**A RESOLUTION APPROVING THE MINOR MODIFICATION TO THE
WINMORE CONDITIONAL USE PERMIT FOR A "DAYCARE FACILITY" AT
515 EAST WINMORE AVENUE
Resolution No. 14/2009-10**

PROJECT: Minor Modification to Winmore CUP for "Daycare Facility" at 515 East Winmore Avenue

Date: June 27, 2009
 To: Applicant
 Copy: Marty Roupe, Zoning Administrator
 From: Randy Dodd, Environmental Planner
 Subject: Environmental Review Comments
 Project: Rev 3 –Goddard Day Care CUP; Plans stamped June 10, 2009

M-3

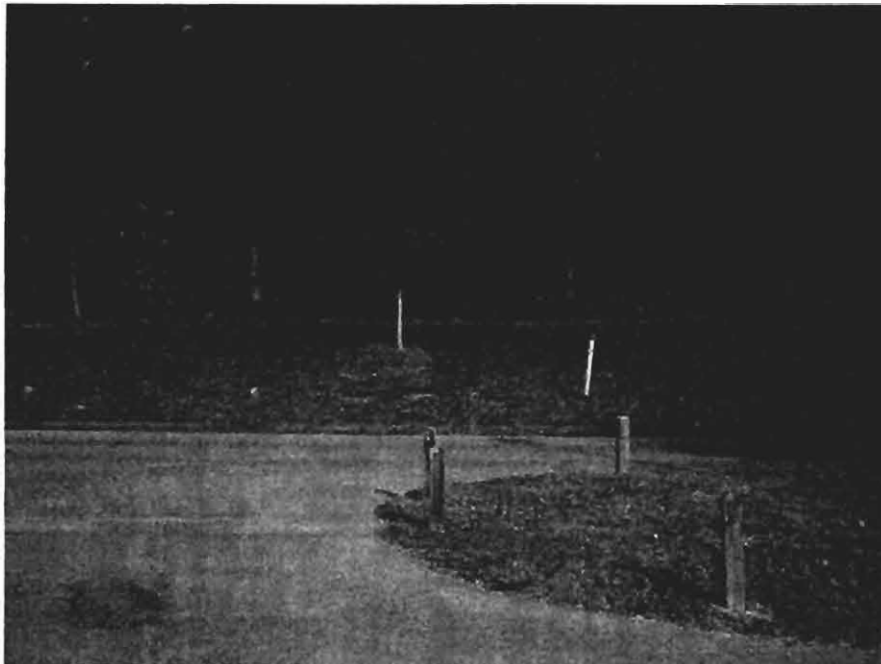
These views are from the Winmore Road cutoff leading to Goddard, and shows the side that is closest to the Bridge and looking over to the bridge. I am trying to understand if they are digging out and leveling this area in order to put in the bio-retention pond? I also am recalling that when the original request came in to exempt day care impervious surface laws, they told us only .6 acres would be impervious for Goddard. In the BoA meeting, the applicant presented a chart saying that 1.1 acres would be undisturbed which seems to me that almost 2 acres will be clearcut first to get everything in place.
